## Public Comments and Responses for Ventilation and Air Quality Module Code and Annex after the First 60-day Review Period

### Informational Copy: NOT Open for Public Comment

FIGURE 3.3. The effect of increasing the rate of air change diminishes as the rate increases.

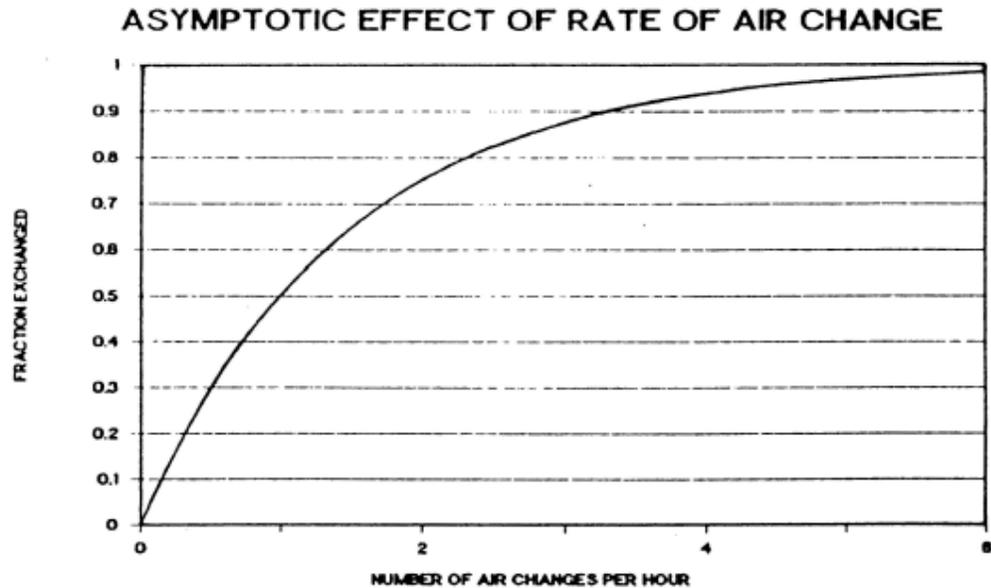
- 6) *Comment:*  
4.6.2.1.7 – There is a point of diminishing returns when it comes to air turnover rates. As turnover rate increases, efficacy decreases. At some point, this matrix could simply result in exponential expense without genuine benefit. -- I question the fundamental logic of piling on above and beyond the ASHRAE standard, which in fact allows for engineering discretion and professional judgment on its own. Has anyone studied representative projects to determine what the unit sizing and operational consequences of this would be? If this logic is to remain, consider an overall cap to the multipliers. – REFERENCE: Furr, A. Keith (ed.). Asymptotic Effect of Rate of Air Change. CRC Handbook of Laboratory Safety, 3rd Edition. Boca Raton, FL: CRC Press, Inc., 1989, p. 105.

*Partially Agree. Code revised to delete additional outdoor air requirements and now specifies using ASHRAE standards for design of outdoor air requirements.*
